Scoping Summary

Southern California Edison Company's Valley South Subtransmission Project

Application No. A.14-12-013 SCH No. 2015051012

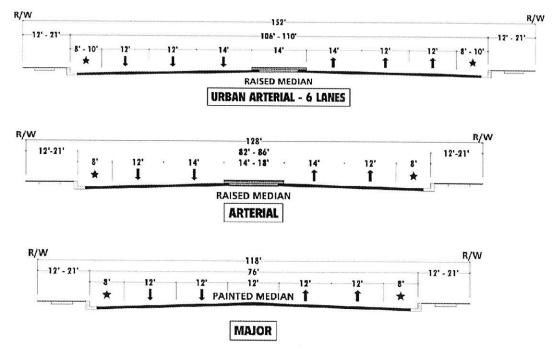
- 2. SCE should take into consideration the recently approved (December 2013) City of Menifee Circulation Element when designing the power pole alignment within the City limits. The poles should be placed at their ultimate location per the City's Circulation Element roadway cross-sections. The poles should be located either within the right-of-way's parkway or completely outside of the public rights-of-way within a private easement, but they should not be placed within the ultimate planned pavement, curb, gutter, trails, or sidewalks. For your reference, Briggs Road is designated as a Major (4 lanes, divided) roadway, McLaughlin Road as a Collector / Interconnected Local (2 lane) roadways, Scott Road as an Urban Arterial (6 lanes, divided) roadway, and Menifee Road as an Arterial (4 lanes, divided). Refer to the corresponding cross-sections below.
